Government of the District of Columbia
Department of Transportation

MEMORANDUM

DATE: March 25, 2019

SUBJECT: ZC Case No. 06-10D – Art Place Block B

Figure 1 – Project Site Plan (Source: Supplemental Submission, Exhibit A, Page 12, March 15, 2019)

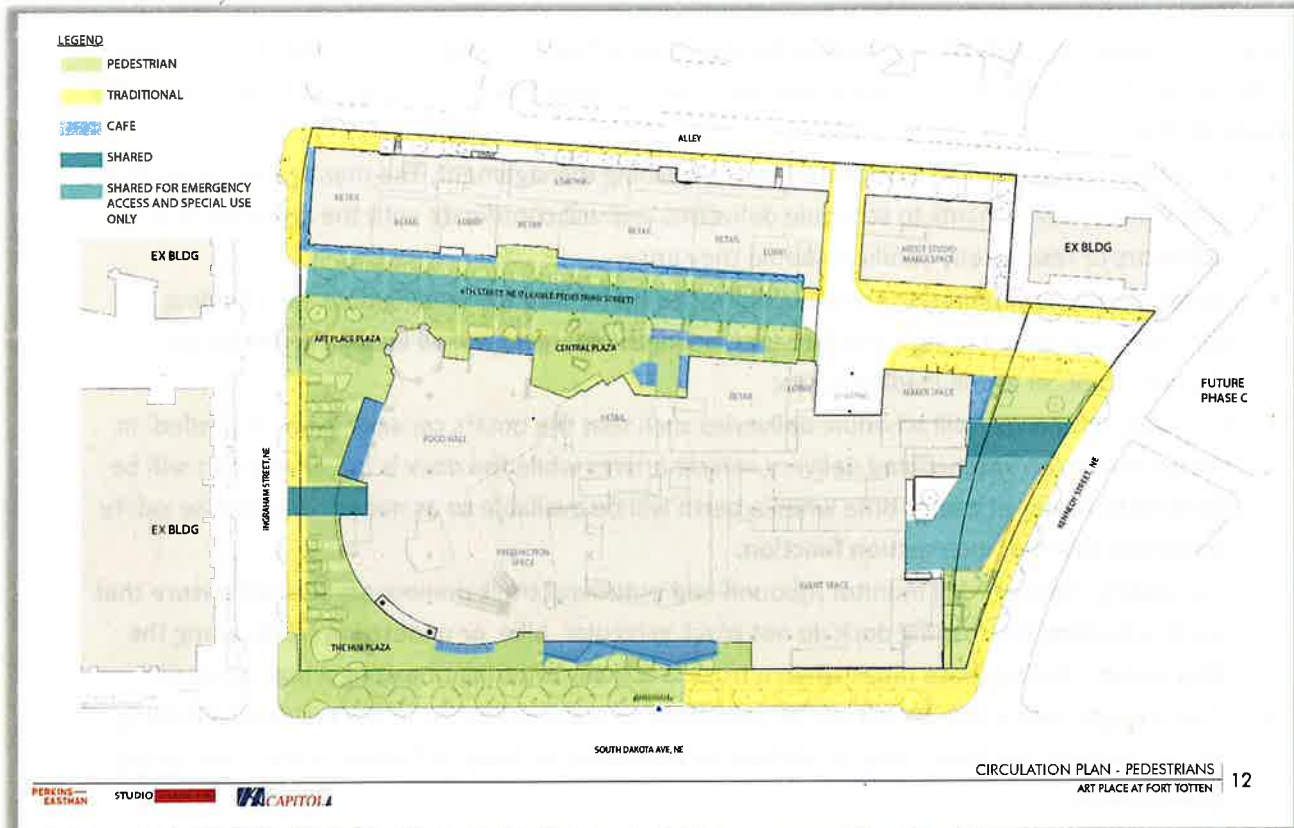
Primary vehicular access to the underground parking is proposed to occur via two (2) curb cuts, one on Ingraham and one on Kennedy Street, and from the public alley. There is one (1) existing curb cuts on Kennedy Street that is proposed to be closed with this development.

Pedestrian access will be via various entrances throughout the project. The future residents of the property may access the units via three lobbies, all with entrances on the private street. The entertainment uses will have its main entrance near the corner of South Dakota Avenue and Ingraham Street, with additional entrances on the private street and Kennedy Street. There will be various entrances for the retail uses and the maker spaces off the private street. Figure 1 below shows the site layout of the project. All building entrances should be at grade so as to maximize green space and minimize paving in public space.

Figure 3 – Riggs Road and South Dakota Avenue Northbound Left Turn Lane Extension
(Source: Wells and Associates, March 14, 2019)

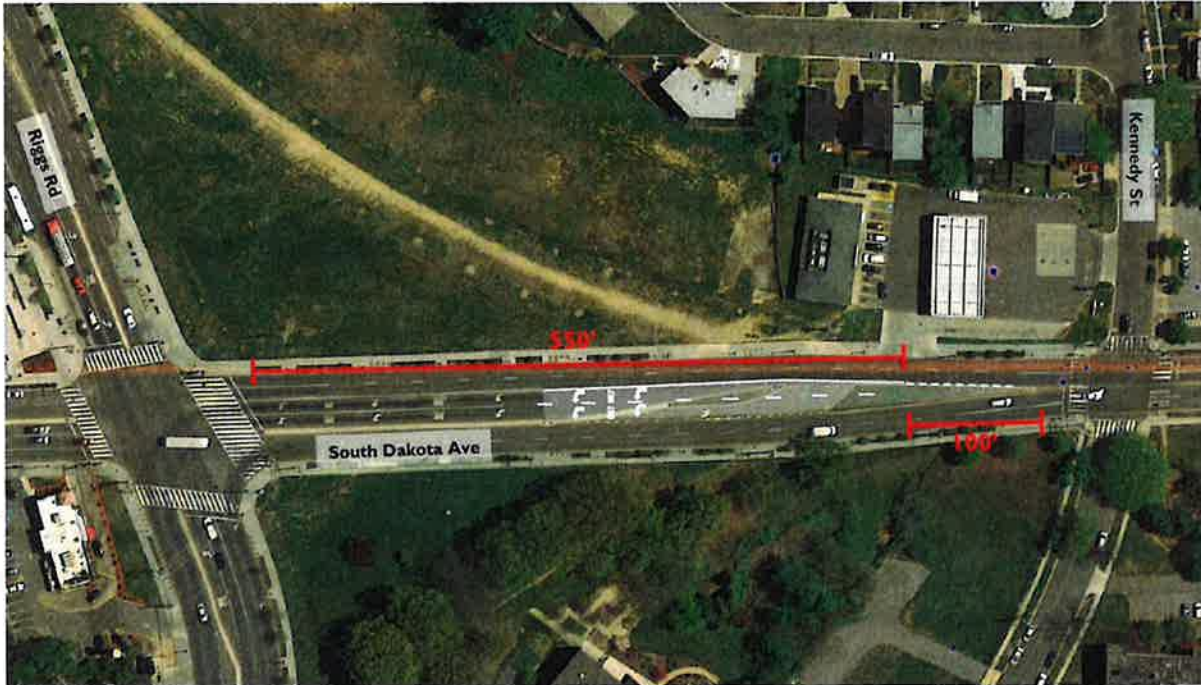
- At Riggs Road and South Dakota Avenue, the Applicant proposes to extend northbound left turn storage into the median. The extension is shown in Figure 3. The Applicant claims the design would accommodate the estimated future queuing at the intersection. The extension would include the restriping of the existing median area currently closed to drivers with bollards on both sides. The restriping would decrease the queues to within 150 feet of background conditions. The median space has been designed to provide future access to the undeveloped parcel of land east of South Dakota Avenue. Consistent with other recommendations made by the Applicant, they propose to mitigate the impact of the estimated northbound left queue with the TDM program described below;

LOADING DIAGRAM
SCALE: 1" = 60'-0"
Z-004

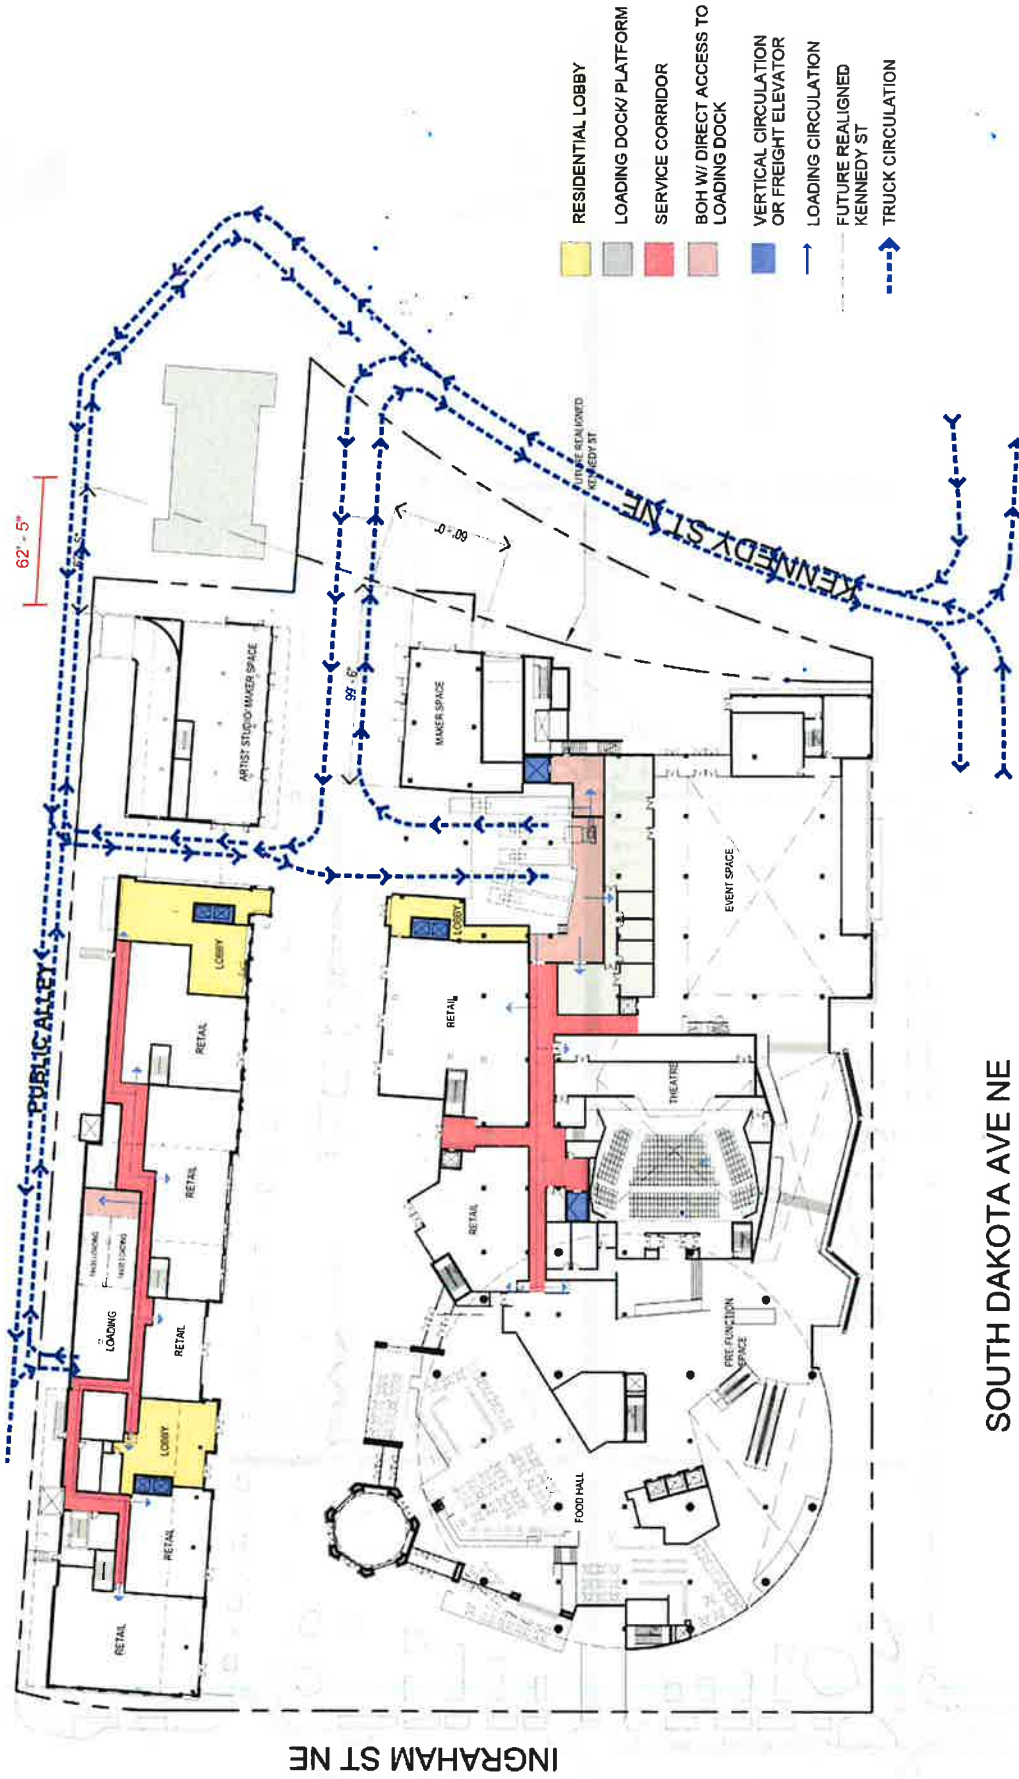
Comment #3: *On the scoping form, we asked you to provide the distance between the new curb cut off the public alley and the future alignment of Kennedy Street. This information is not included in the CTR.*

Comment #4: *On the scoping form, we asked you to provide more information on the new circular driveway off Kennedy Street. We didn't feel that this was discussed enough in the CTR. We need more information on how it will function, and then how it will be removed when Kennedy is realigned.*

Comment #5: *How do you access the loading to the western residential building that's between the private street and the alley? Figures 15 and 16 don't look like they match.*

Comment #7: *How do you enter the lobby of that residential building and the artist studio maker space? Where are the pedestrian access points to those buildings?*

Response: Please see Attachment 1. The curb cut from the public alley and future alignment of Kennedy Street are 62' 5" apart, measured edge of curb to edge of curb.

Response: As shown in the attached Attachment 1, revisions have been made to the area that was previously shown as a dedicated circular drive. This area is now planned as a pedestrian plaza area to be separated from the parking access drive by removable bollards or other similar vehicular control devices. It has a curbsless section, which can operate as a secondary drop off area for those with special needs or authorization attending planned special events. At other times, the plaza area is intended to be reserved for pedestrian activities. At the time of the Kennedy Street realignment, the plaza area will be eliminated.

Response: The loading to the western residential building is accessed from the alley as shown on Attachment 1. Swept area diagrams are provided for both loading spaces and are included in Attachment 2.

Response: Pedestrian access to the western residential building has been highlighted on Attachment 1. Two (2) main lobbies are provided to the western residential building via 4th Street and several doorways to the maker space are provided off of 4th Street. It is noted that the building connects above the alley for the residential uses.
